FINAL PLAT

HILLCREST CENTER

SITE PLAN REVIEW

SUBJECT: HILLCREST CENTER SITE PLAN - TRAFFIC ASSESSMENT

SITE PLAN AND RECOMMENDED DRIVEWAYS

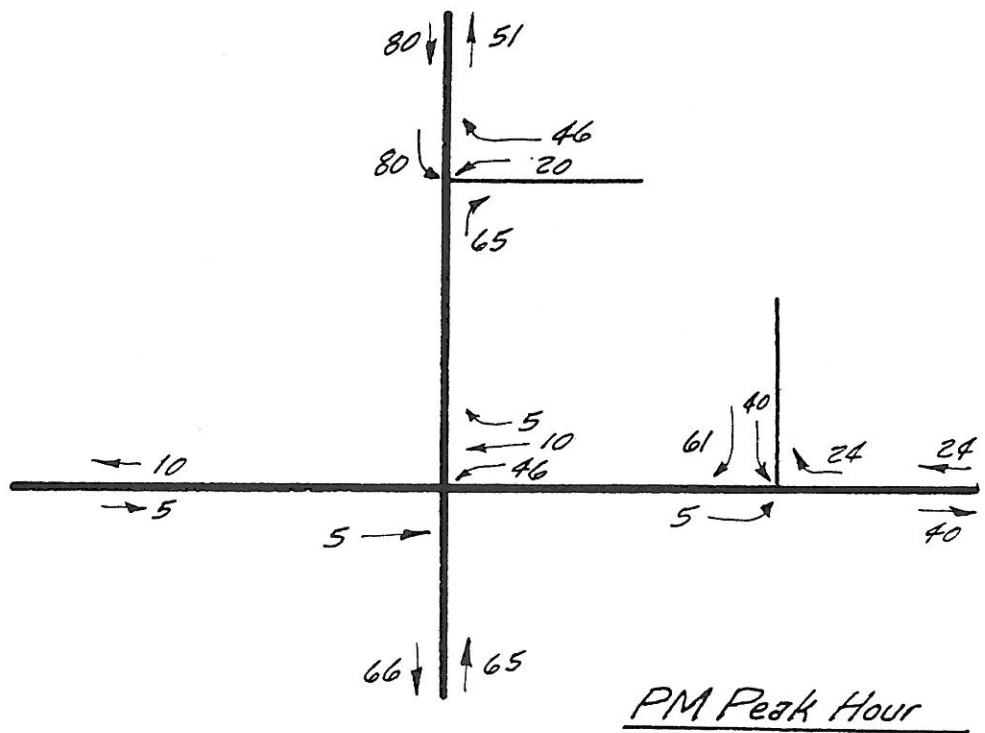
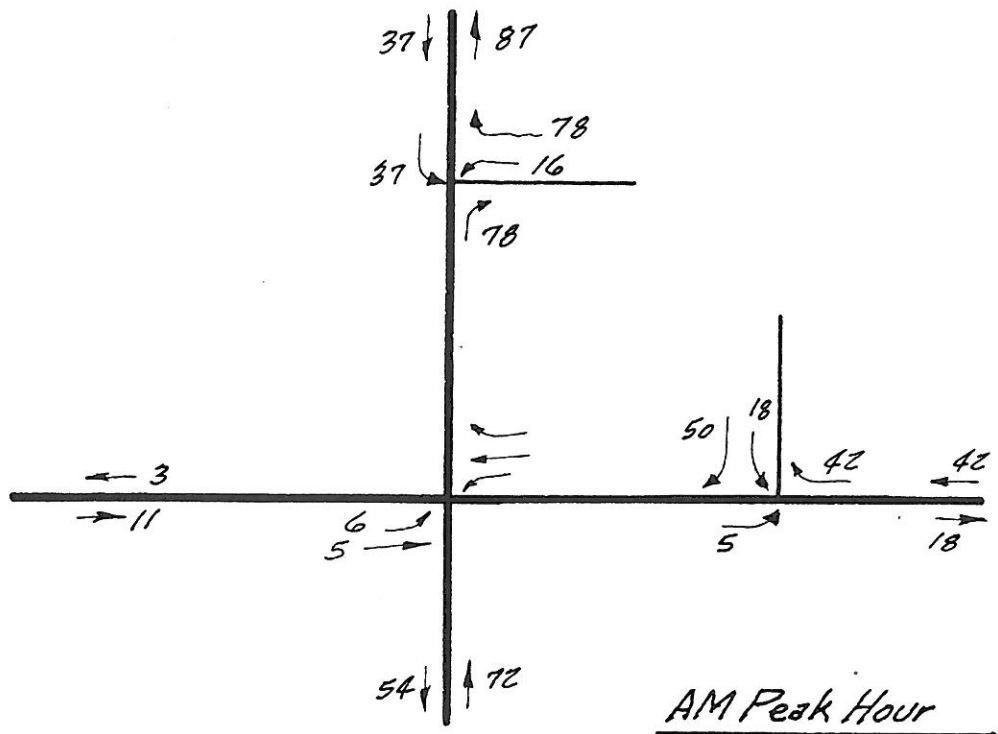
The site plan as submitted has two driveways shown - one at the north end of the site connecting with SH 205, and the other at the south end of the site connecting with FM 552 (see Figure 1). It is important at the intersection of two major roadways that driveways not be placed right at the intersection. In this particular case, the northerly driveway has been properly located, but the southerly driveway is much too close to the intersection. This driveway should be moved eastward to the east end of the parking lot shown on the site plan. The displaced parking spaces can then be relocated where the driveway is currently shown. By having this driveway moved away from the corner, traffic which may be stopped at the intersection will not impede traffic from entering the premises. Therefore, the overall operation will be better for both the public and the convenience store.

It is also understood that additional retail space may be built in the future adjacent to this store as Phase 2. The northerly driveway may have been planned to serve both phases. Because of the high speed of traffic along SH 205 in this area, as well as the number of turning movements which may result with the additional retail space, SH 205 may need to be widened at that time to accommodate a deceleration lane or left turn lane. It is not felt that such measures are necessary for the site plan as shown.

Relocate the FM 552 driveway eastward to the east end of the parking lot, or farther, as shown in Figure 1.
